D3016-041 SEAT FRAME ASSEMBLY

DRAWING NO. D3016	TITLE SEAT FRAME ASSEMBLY	REV. A	DART AEROSPACE LTD ENGINEERING ORDER	D.E.O. NO. D3016-A-1	SHEET NO. SHEET 1 OF 1	SCALE NTS
DRAWN <u>1</u>	CHECKED <u>CP</u>	MFG. APPR. <u>PC</u>	APPROVED <u>MAP</u>	DE APPR. <u>TH</u>		
DATE 10.01.29	DATE 10.01.29	DATE 10.01.29	DATE 10.01.29	DATE 10.01.29	DATE 10.01.29

TO REVISE D3016-11 SADDLE'S HOLE SIZES

D3016-11 SADDLE

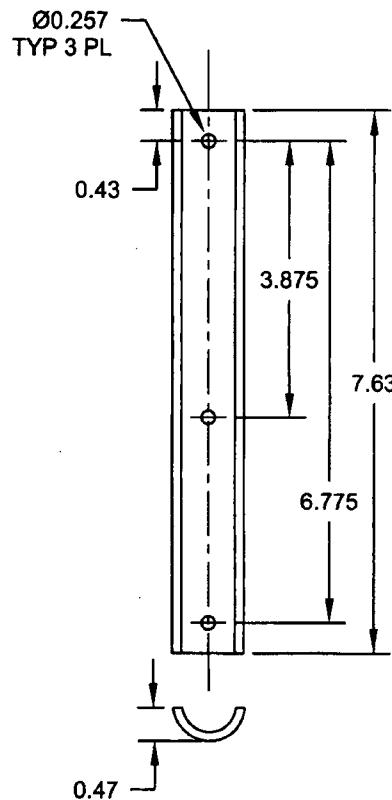
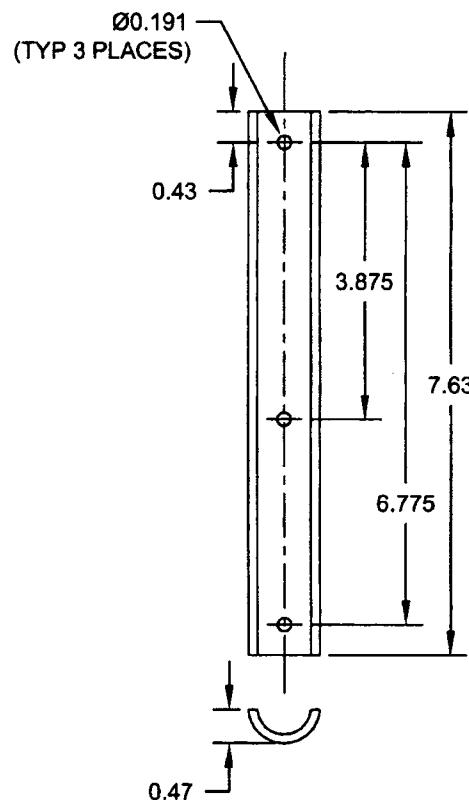
DETAIL D3016-11 SADDLE (SHEET 3): Ø0.257 TYP 3 PL WAS Ø0.191 (TYP 3 PLACES) AS SHOWN:
